Subdivision Application for 430 Turtle Bay Court SE

<u>Salem, OR 97306</u> File # 20-119160-LD

This letter addresses our response to each of the City of Salem Completeness Review Letter Items Dated January 12, 2021.

UTILITY PLAN

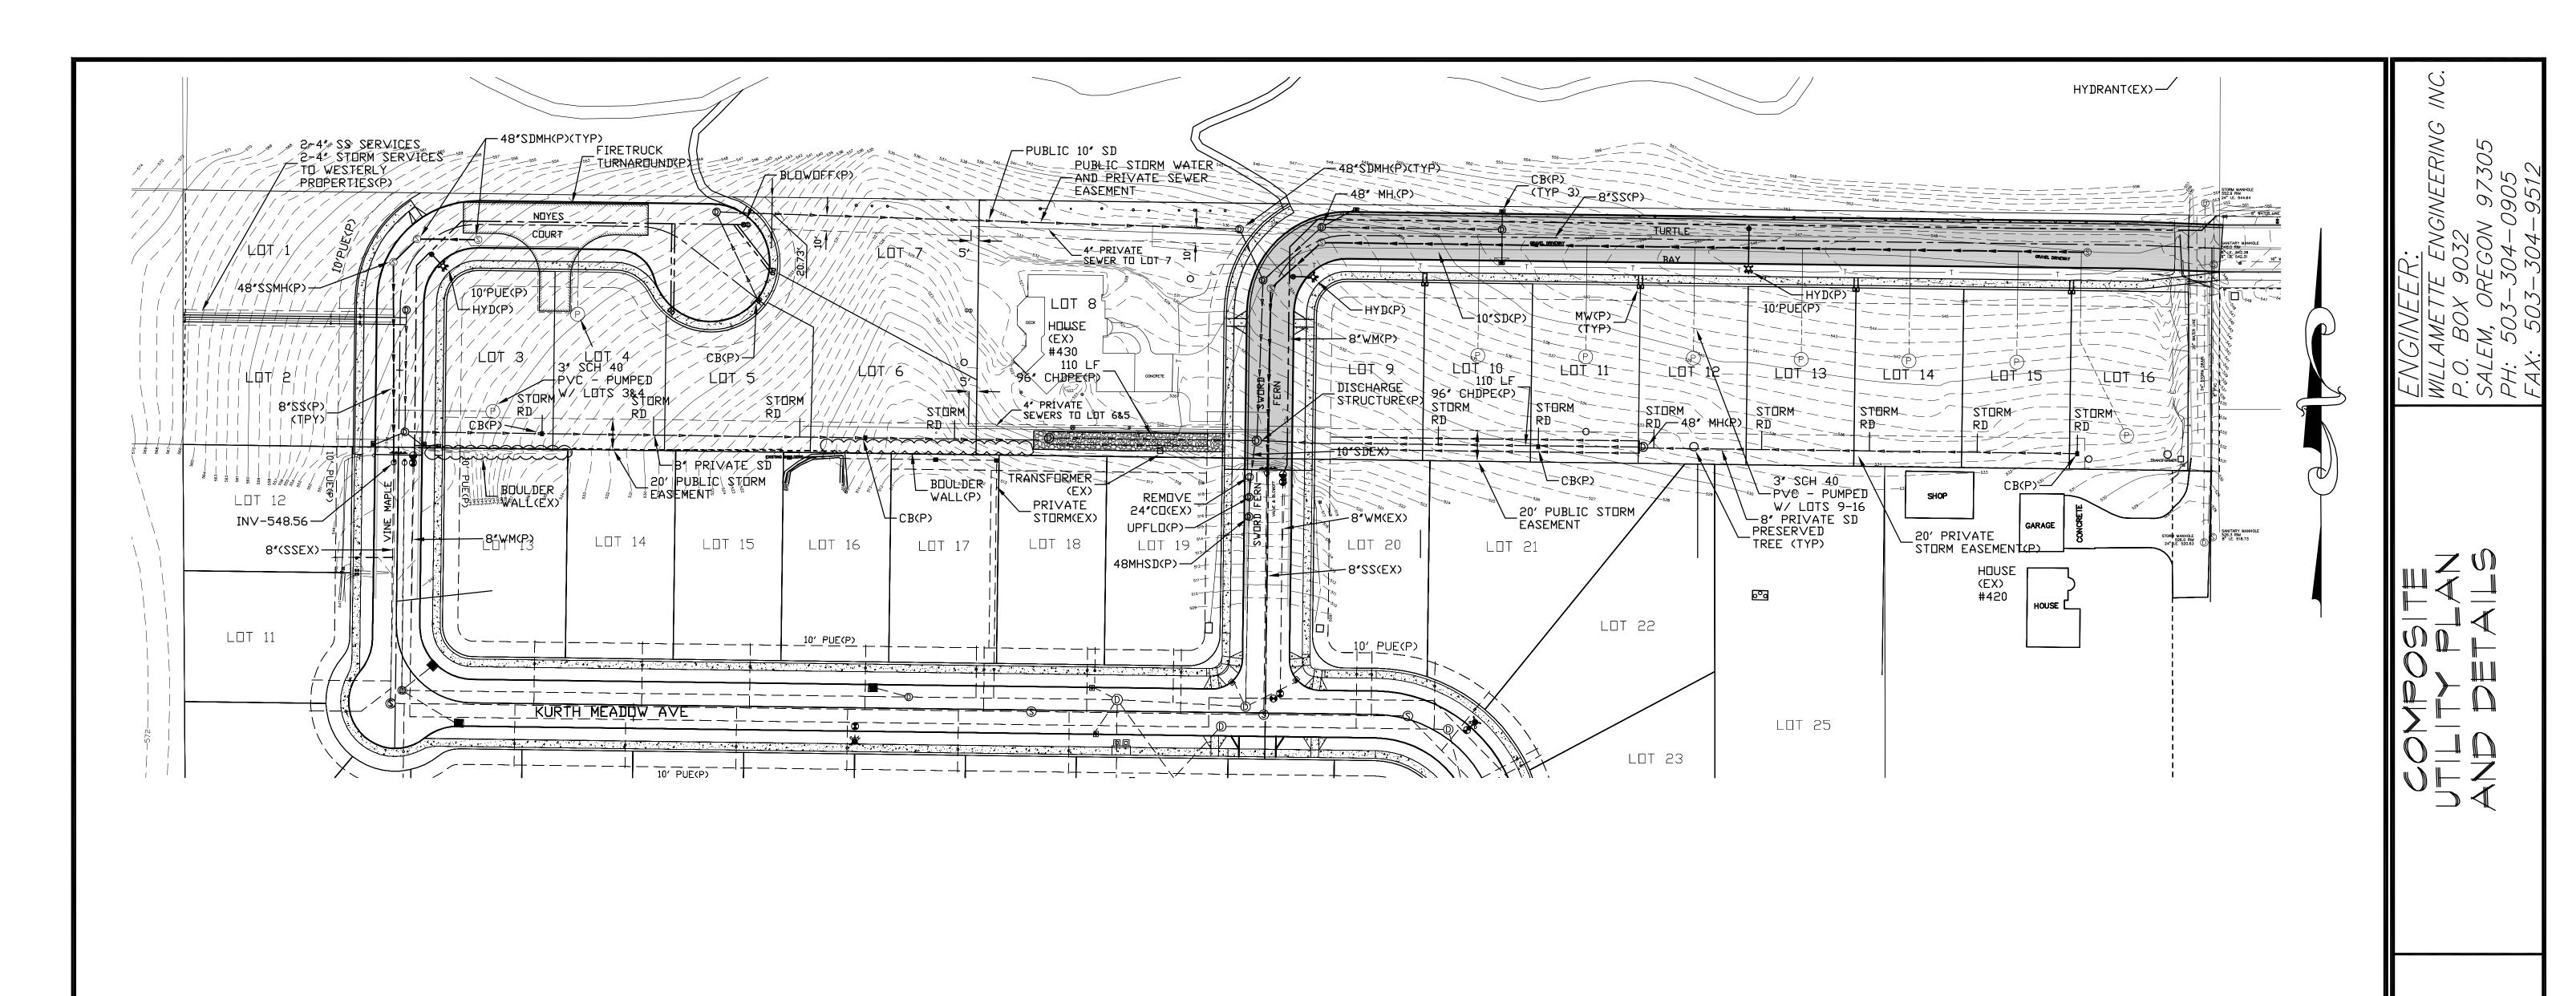
6. The proposed Design Exception for sewer lateral length for Lot 5 will not likely be approved. The applicant is advised to contact Public Works staff to coordinate an alternate sewer design.

8. The neighboring property to the west does not appear to have access to public sewer and storm and may warrant extension of service through the subject property.

A sewer design that does not require a design exception has been determined and it shown on the updated utility plan.

This has been considered. Storm and sewer easements mainline service tees will be provided to the westerly property.

STORM MATER AREAS AND PRE-DEVELOPMENT TRAVEL TIME

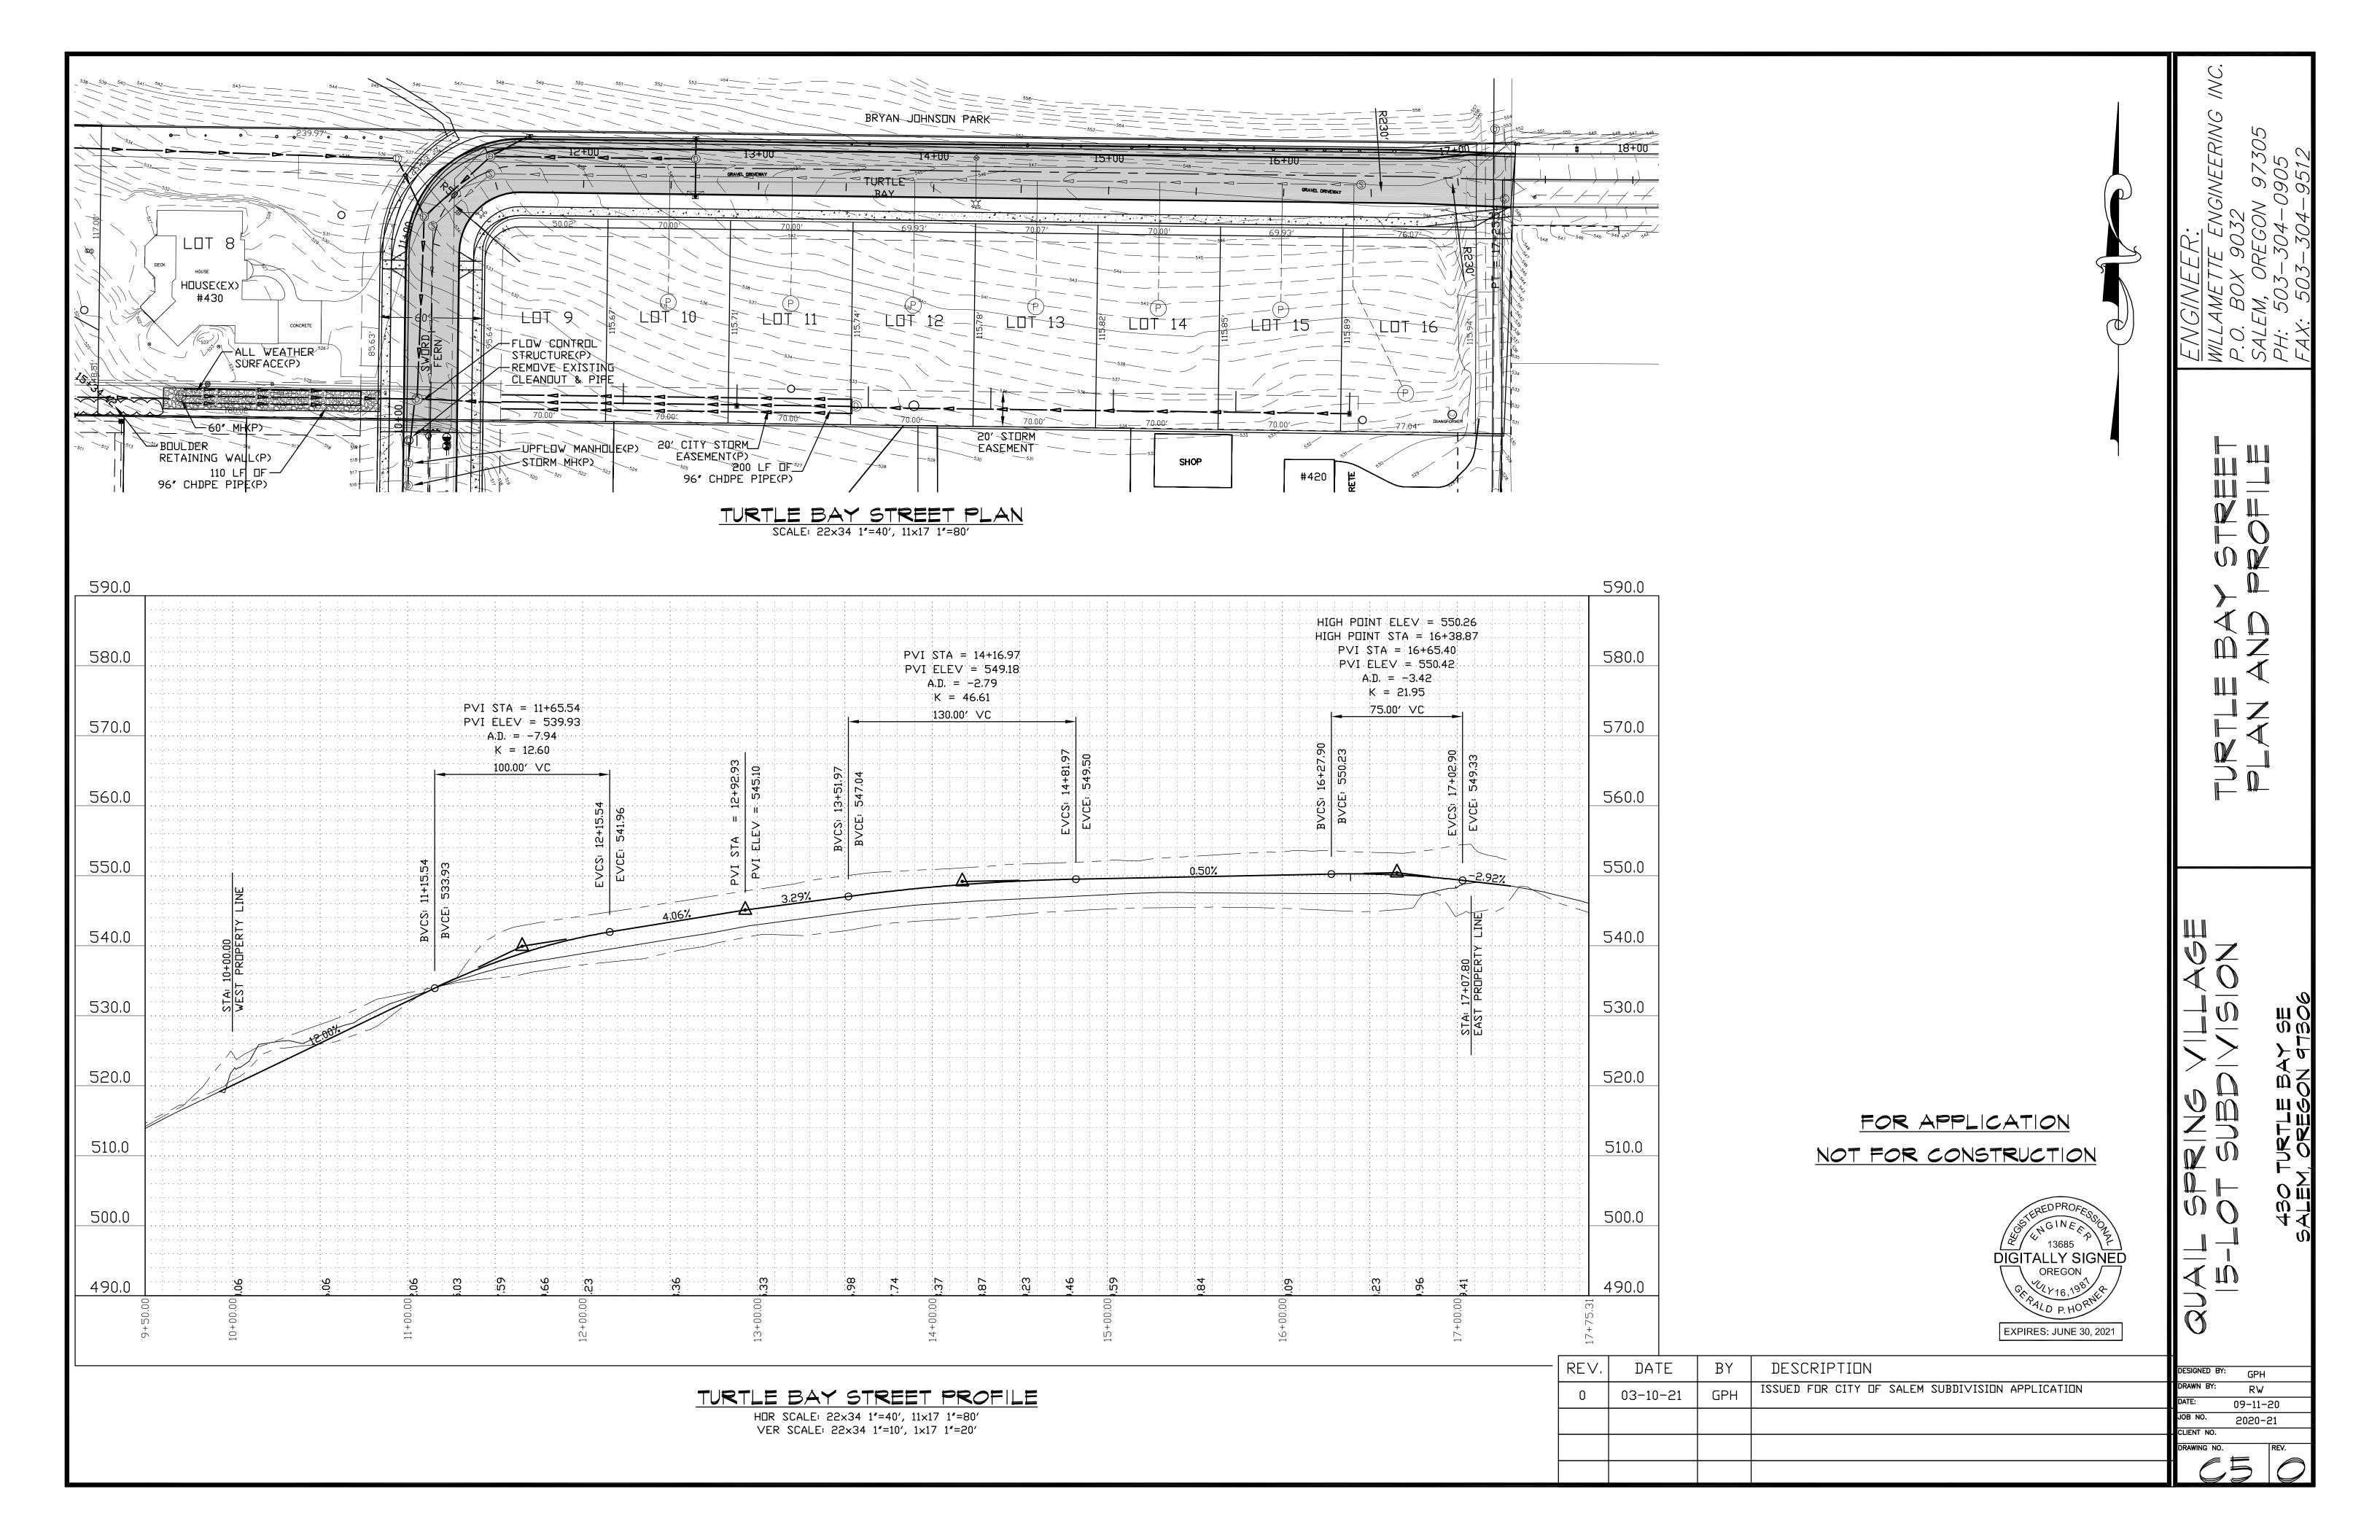
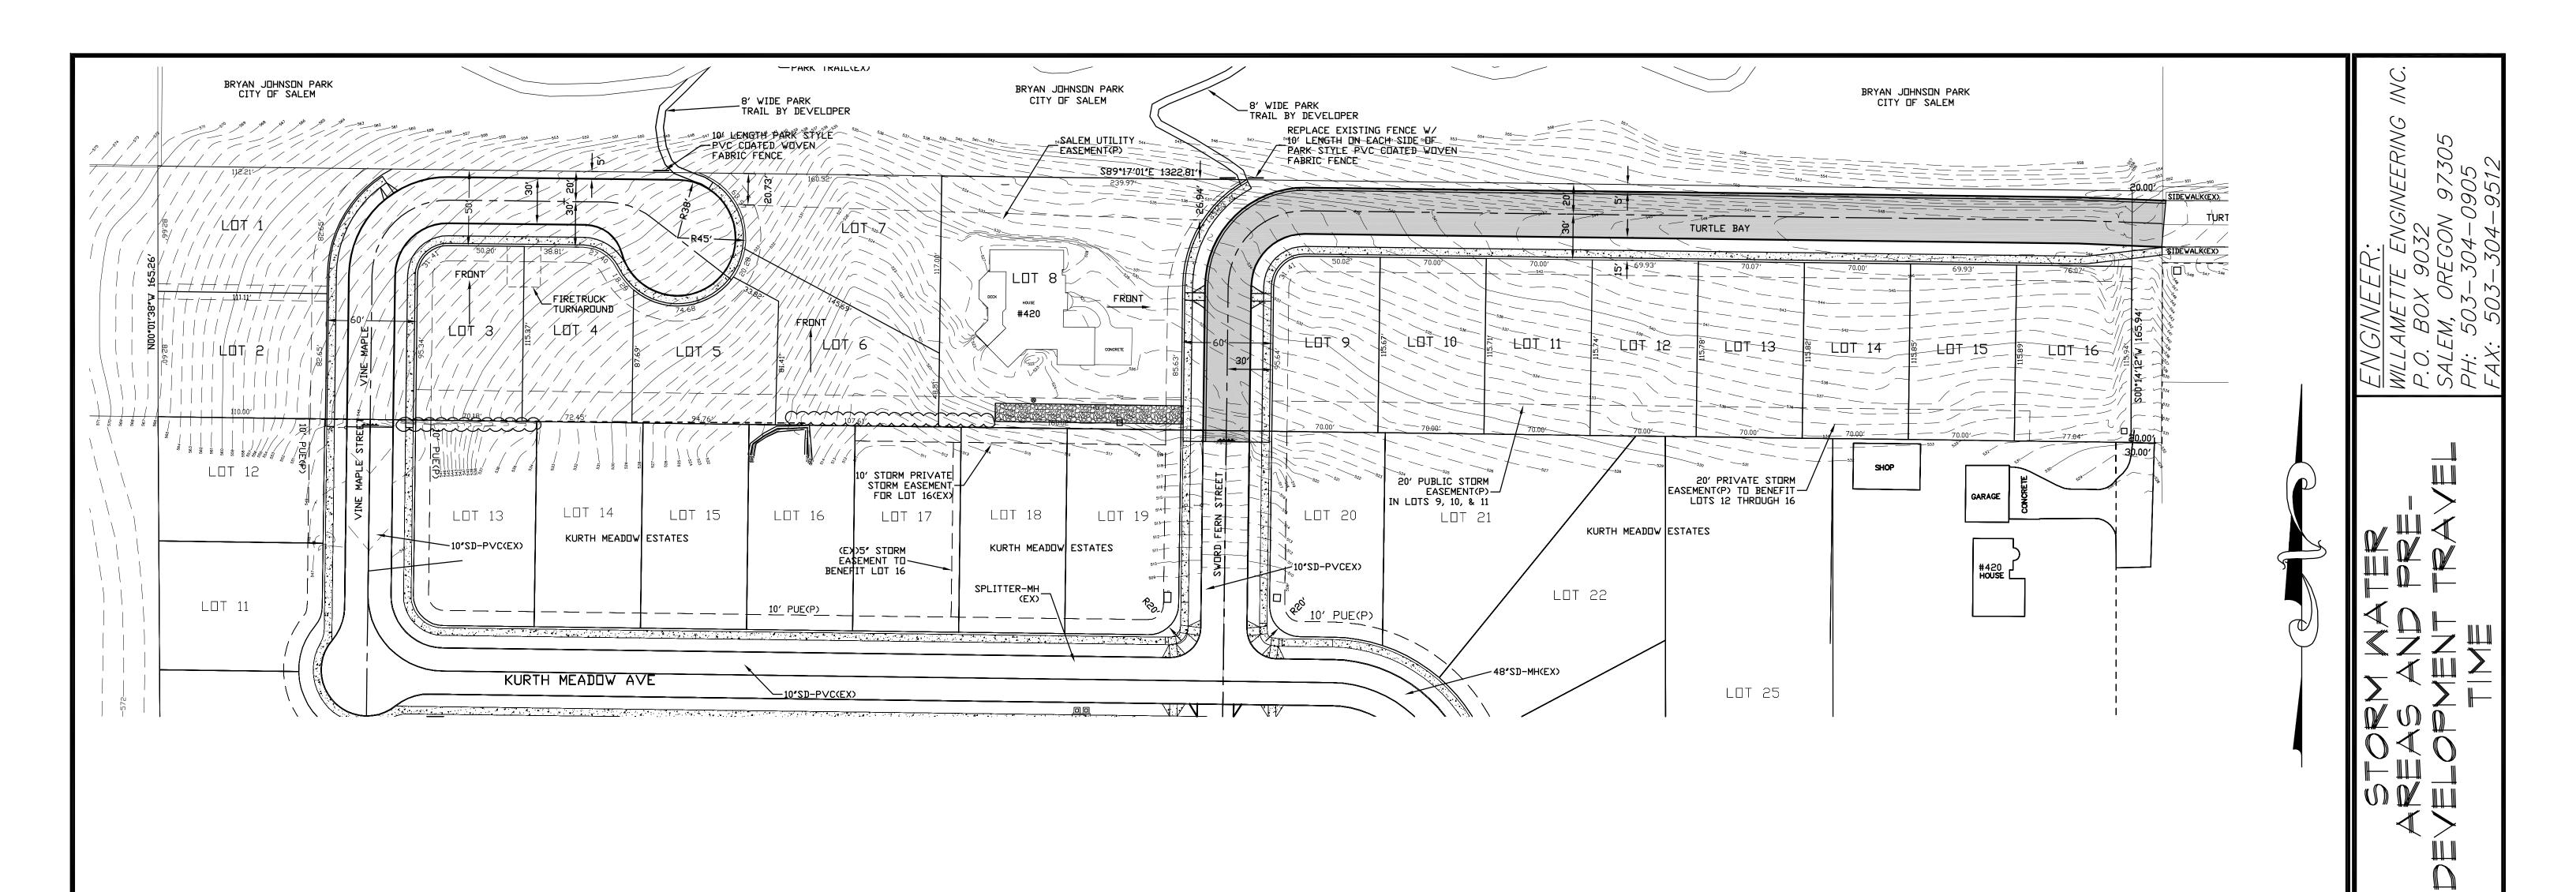
4. The proposed design for stormwater does not appear to meet City standards. The applicant is advised to contact Public Works staff to coordinate an alternate design.

7. The proposed storm main at the rear of Lot 11 conflicts with an existing tree that is shown to be preserved.

Further discussions with Salem Public Works department have determined that use of existing Kurth Meadows Water Quality Pond will not be allowed.. Updated Plans are attached and new Hydro CAD calculations are attached.

For detention buried pipe is proposed. For water quality an up-flow manhole with filter is proposed.

With the proposed detention system the tree must now be removed.
